**BALTIMORE COUNTY, MARYLAND
DEPARTMENT OF PUBLIC WORKS AND TRANSPORTATION
DIVISION OF CONSTRUCTION CONTRACTS ADMINISTRATION
111 WEST CHESAPEAKE AVENUE
TOWSON, MARYLAND 21204**

Contract No. 25010 PO0
Project No's. 107011861
Jacksonville Senior Center Expansion -
3605 Sweet Air Road, Phoenix, Maryland 21131
Phoenix – District 10c3

ADDENDUM NO. 1

DATE: 8/8/2025

2 **AID-TO-CALL WIRING DIAGRAM**
SCALE: 1" = 1'-0"

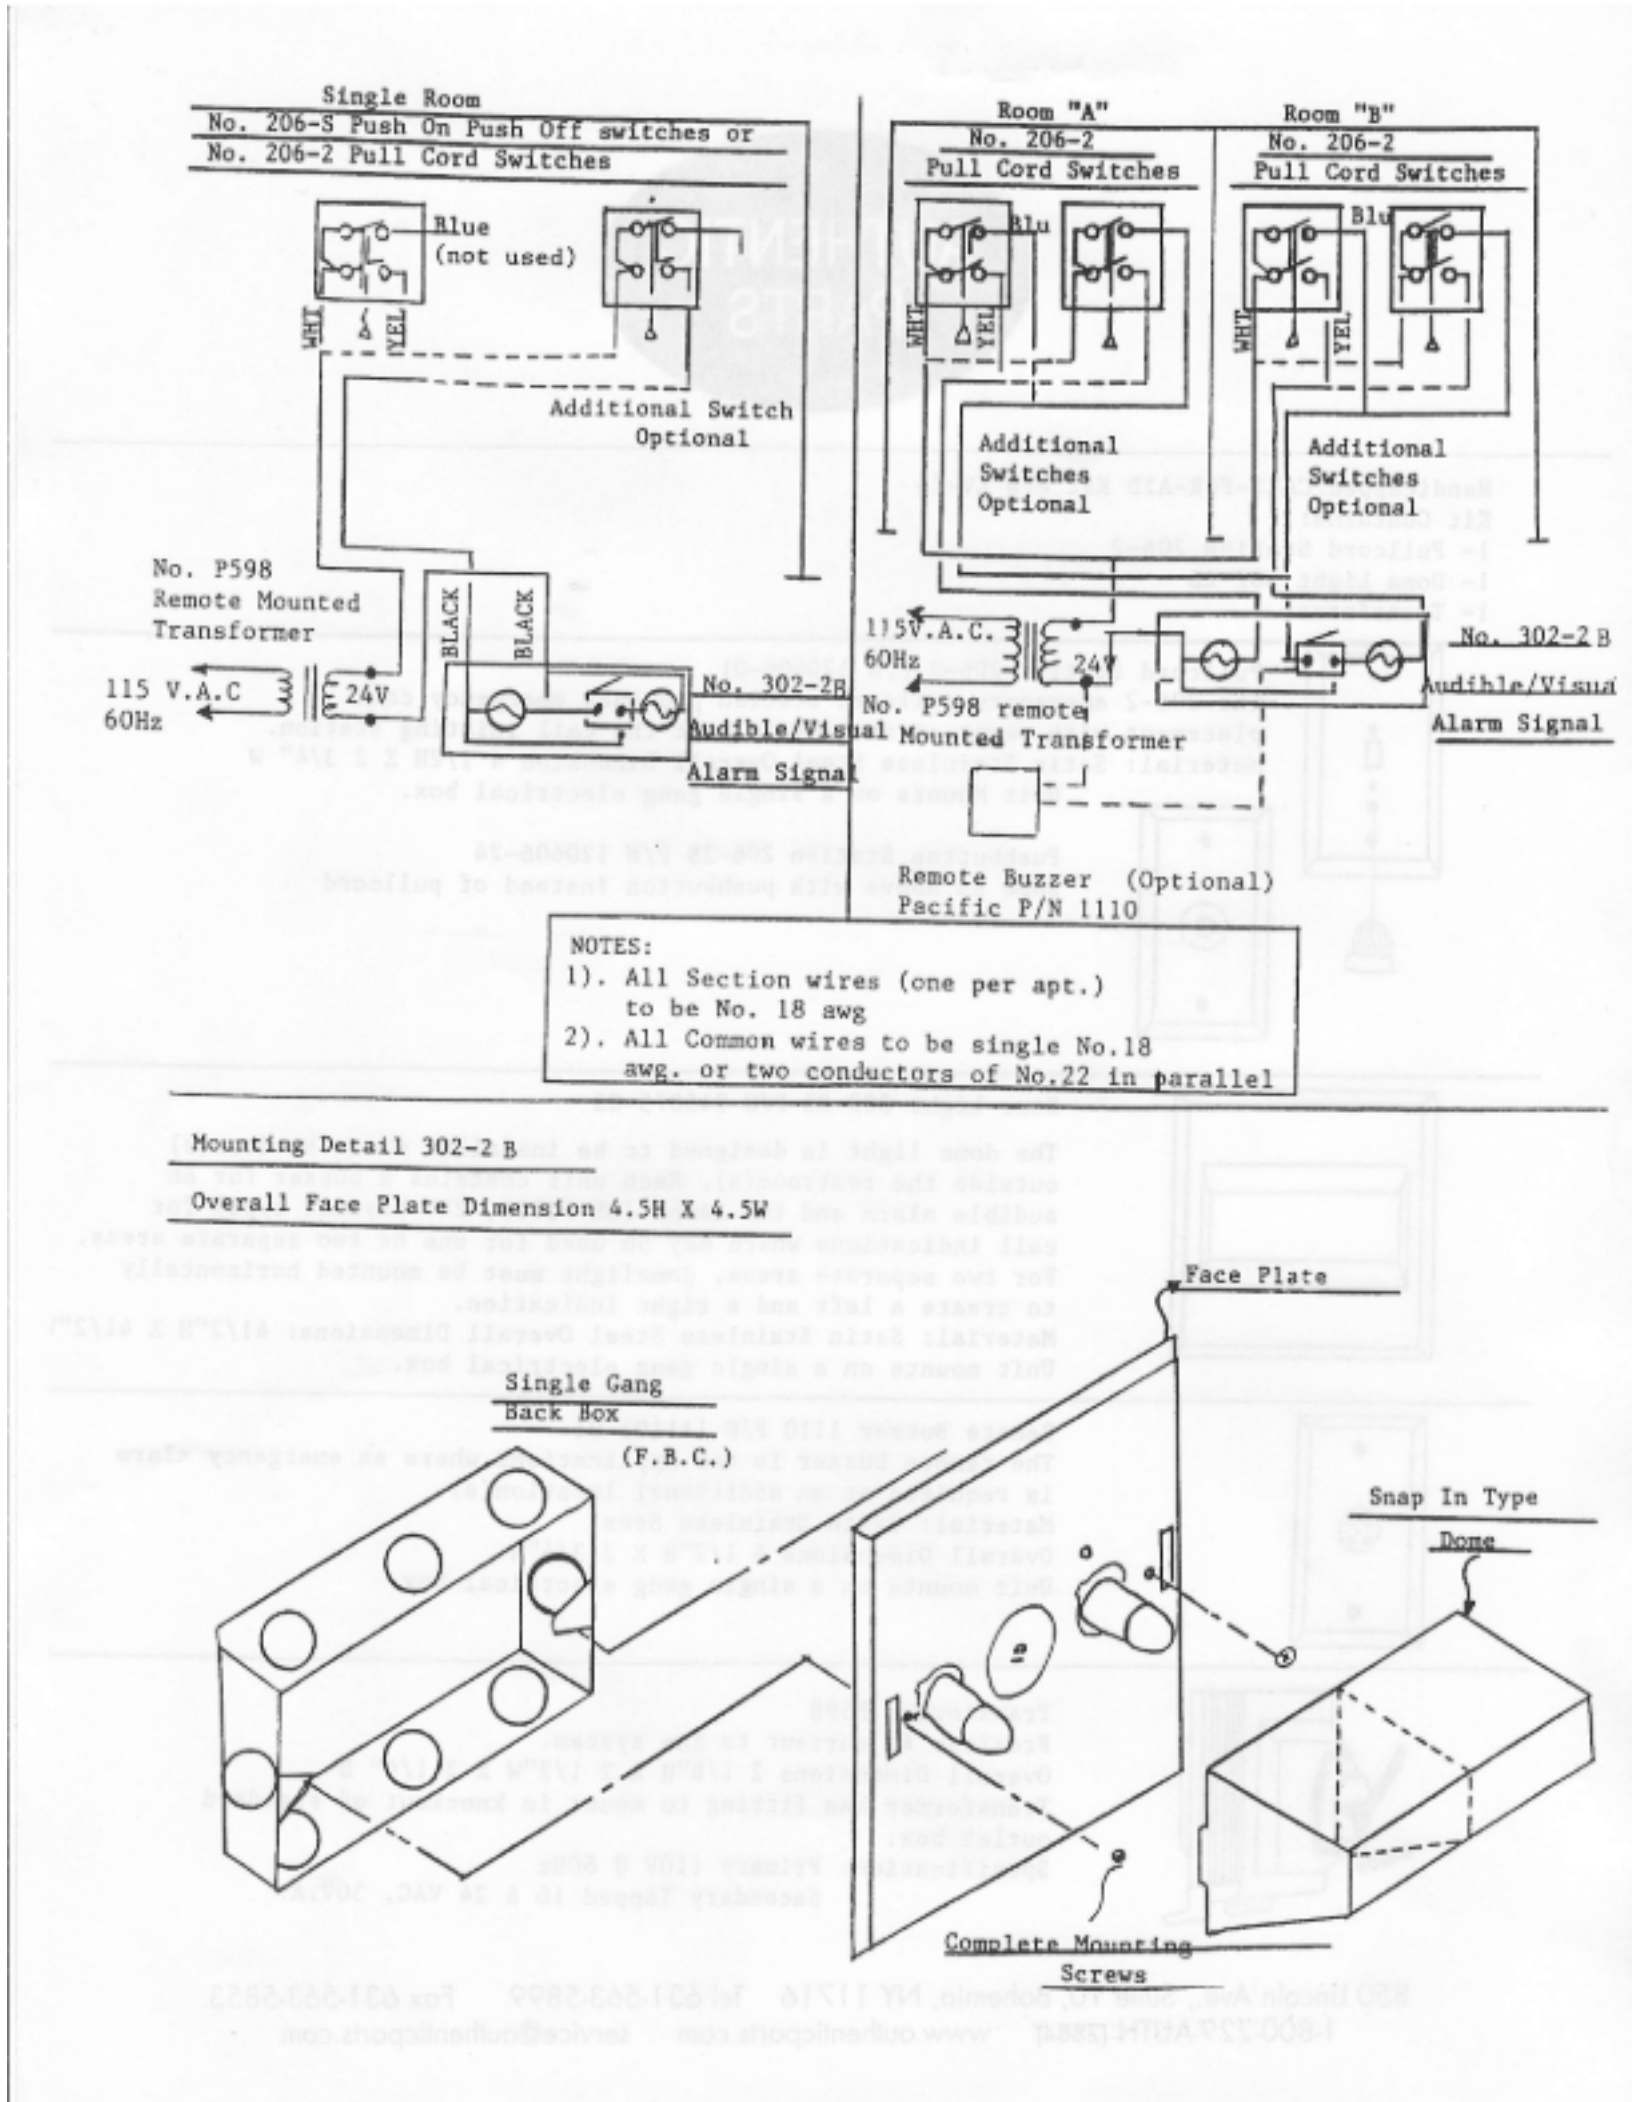
80	On A701 it indicates mini blinds at the windows. On A309, note 3 states to provide electric translucent roller shades. Please confirm the window treatment type needed.	See spec section 12 24 13 Window Shade Systems for products
81	On sheet A310, detail1 the storefront systems show SF-28. Please confirm where SF-28 is located.	Confirmed, there is no SF 28 in this project.
82	Please provide fire pump control specifications for electric-drive, vertical turbine fire pump equipment in Section 213213.	See revised specs section 21 32 13 to include fire pump controller information.
83	Please advise if electronic/digital signatures are an acceptable means of authentication and intent to be bound by/obligated to a submitted proposal.	See Page 3 of the Contract Proposal book for instructions on completing the bid process
84	Drawing T001 indicates that the contractor is responsible to furnish and install the Call-For-Aid system. Please provide a specification for this system.	See Sheet T001 and Revised sheet T302 for information

SHEET DESIGNATION	CONTRACT NUMBER
SW202	25010 P00
	JOB ORDER NUMBER 10-701-1861 SHEET 190 OF 195 DRAWING NUMBER 2025-0407 FILE NO.: 8

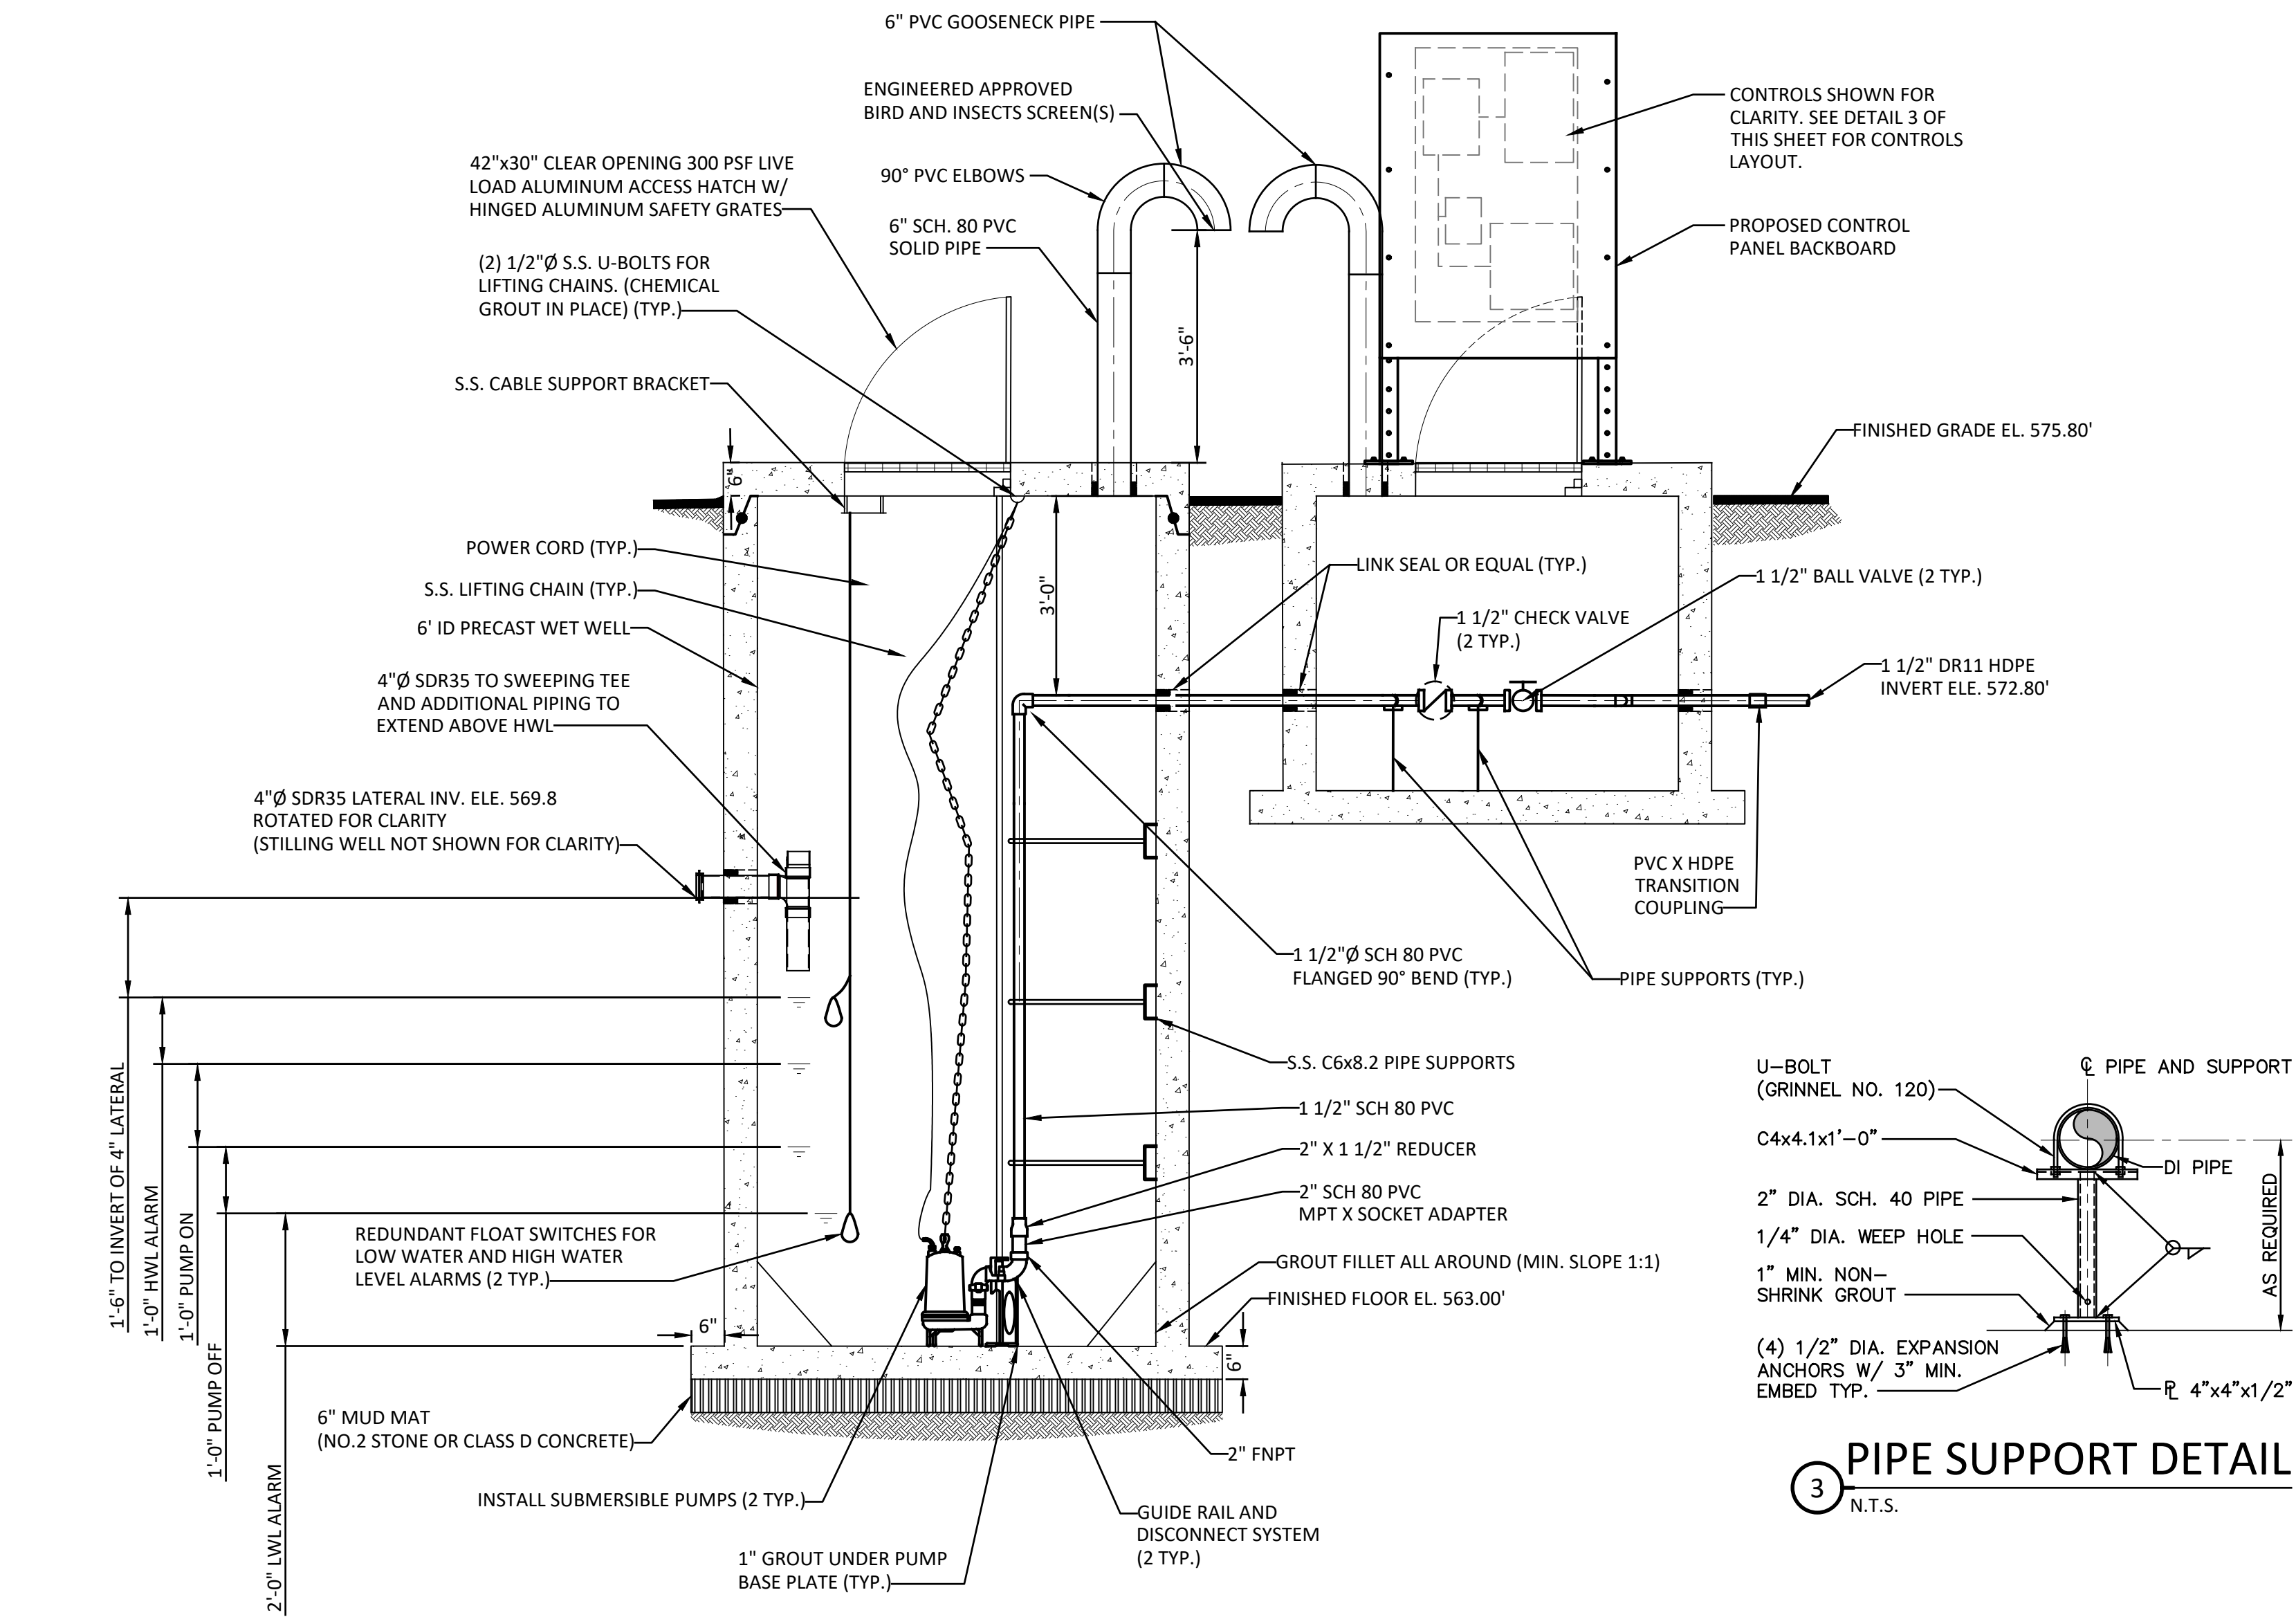
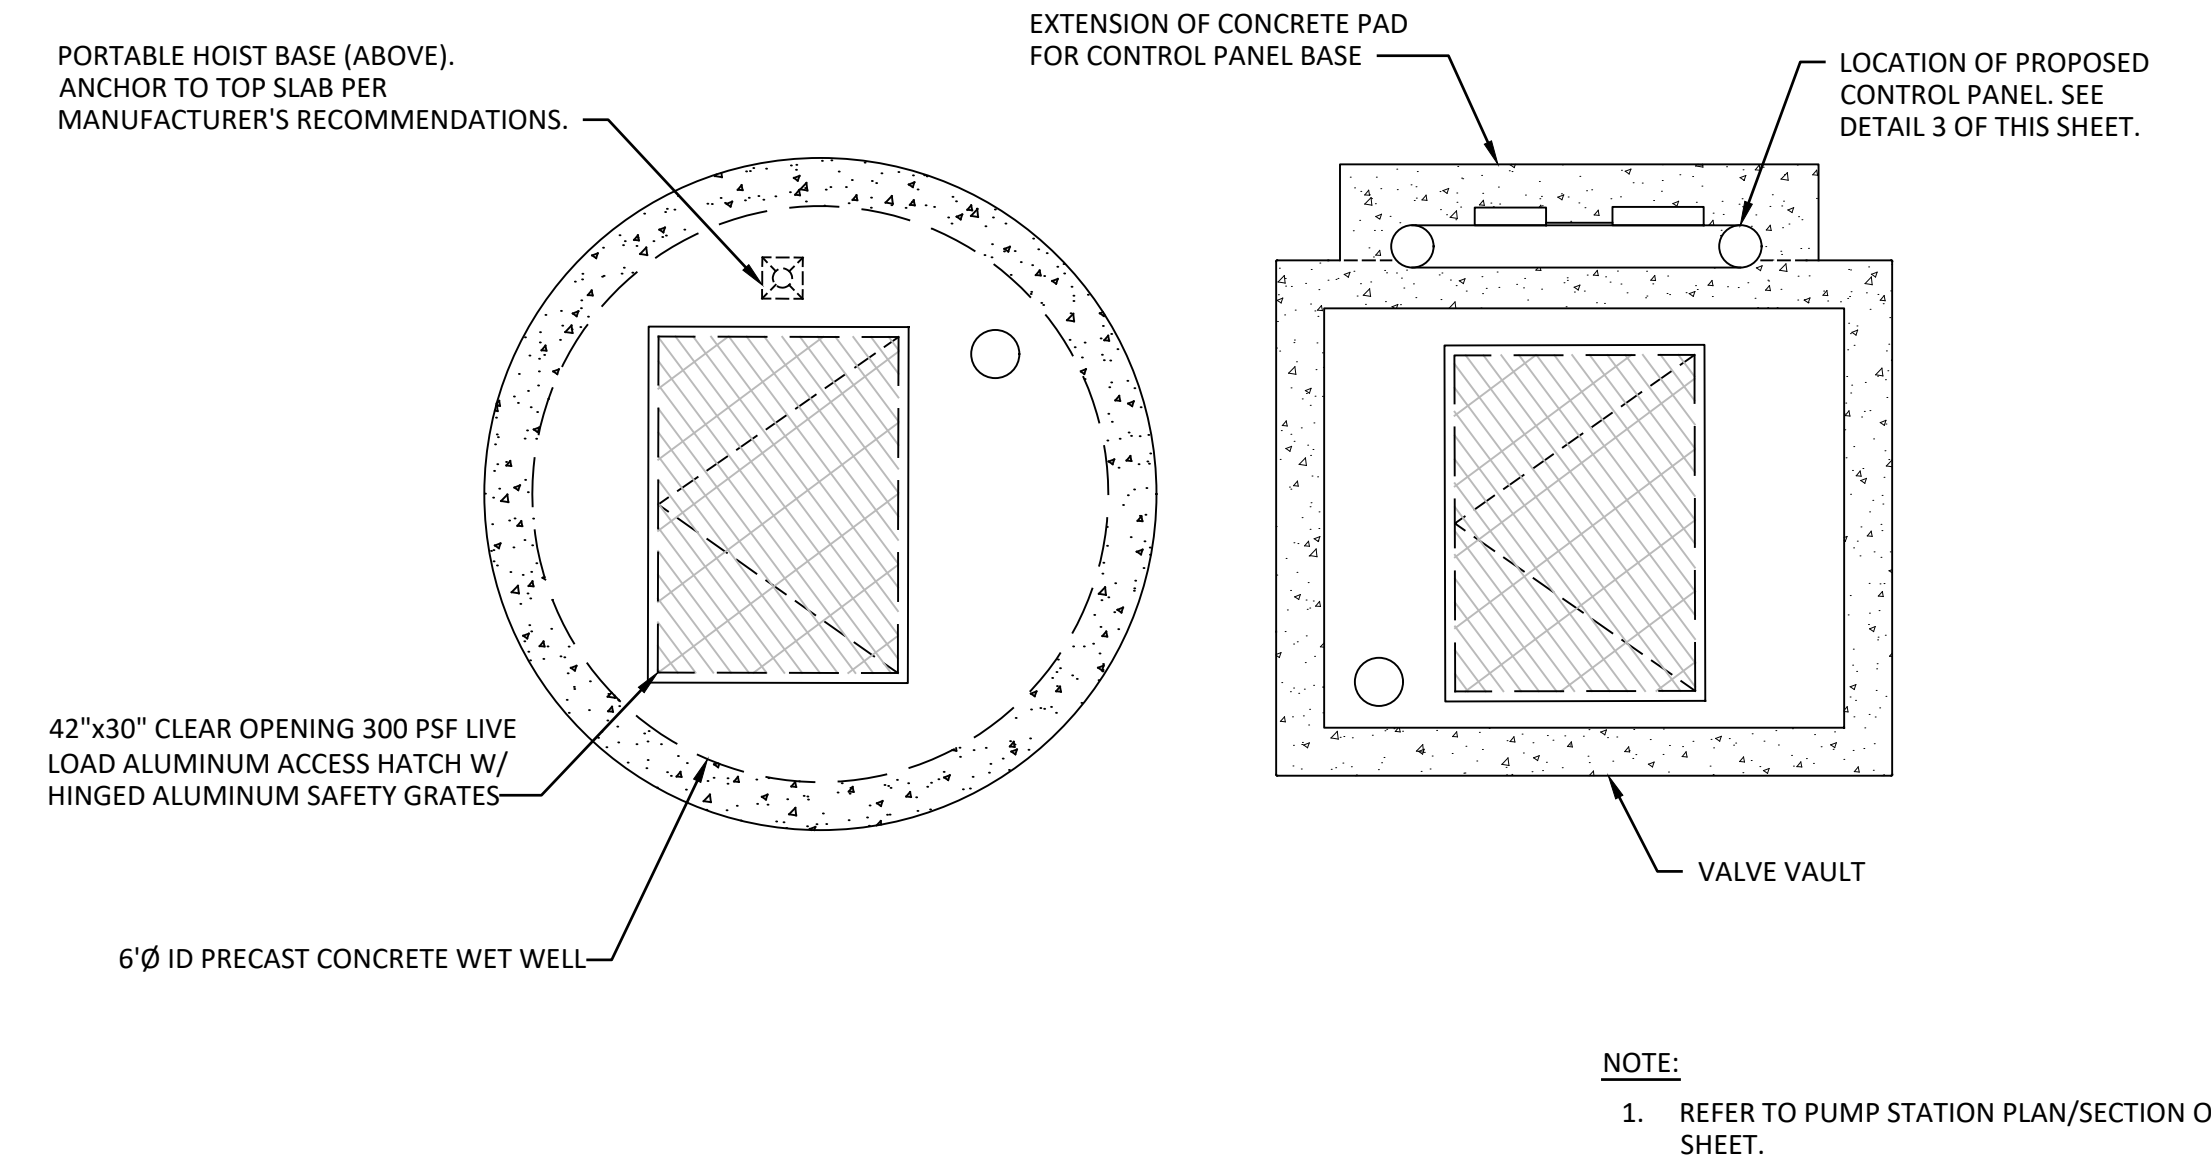
13	<p>On sheet SW202/Detail A, the finished floor elevation of the pump station is shown to be elev. 56 .00. The inlet is also shown as 56 .8. The third digit is missing in both elevations, please confirm correct elevation.</p> <p>Additionally, SW203 shows the finished floor elevation of the Pump Station to be at about 562.00 +/- . Please confirm finished floor elevation and inlet elevation of the pump station.</p>	<p>Pump Station Finished Floor Elevation = 563.00'</p> <p>Inlet Elevation is 569.8'</p>
14	<p>On the SW drawings, the invert elevation of the 4" gravity sewer coming into the pump station does not seem to match the elevations shown on the septic system profile. What is the correct invert elevation of the incoming gravity sewer into the pump station?</p>	<p>The correct inlet elevation should be 569.8'. See revised Sheet SW203 for additional elevations or schedule as shown on Sheet SW202</p>

31	Drawing SW 202 shows cross section of wet well and valve vault. Please provide elevations or heights of the structure and wall thickness. The notes on the drawing for the valve vault shows dimensions 5 – 4 1/4W- 6 - 5"L- 4-20". Not clear of the meaning 4-20".	Valve Vault Dimensions: Width = 5'-4 1/4" , Length = 6'-5", Height = 4'-9/20", and Wall Thickness = 6" See revised Sheet SW202
32	Drawing C 521 states typical section 1 concrete site wall "see structural plans." We could not find it on structural plans. Please provide sizes of footings and wall thickness.	See structural sheet S101 and corresponding wall sections.
33	Please provide sizes for footing, wall thickness reinforcements for the weir walls in MB#2.	See structural sheet S101 and corresponding wall sections.
34	On the site drawing E003 drawing note #14 it indicates that 4 of the existing site lighting poles are to be reused with new fixture heads installed on them. I have looked at the civil drawings and I don't see any information regarding these existing light poles. My question is, are these 4 existing poles being reinstalled in the same location using the same pole bases? Or are these new locations requiring new bases and conduit?	Four existing light poles are to be salvaged - refer to sheet C111, Demolition Note D-7. The existing poles will be reinstalled in new locations shown on revised sheet E003.
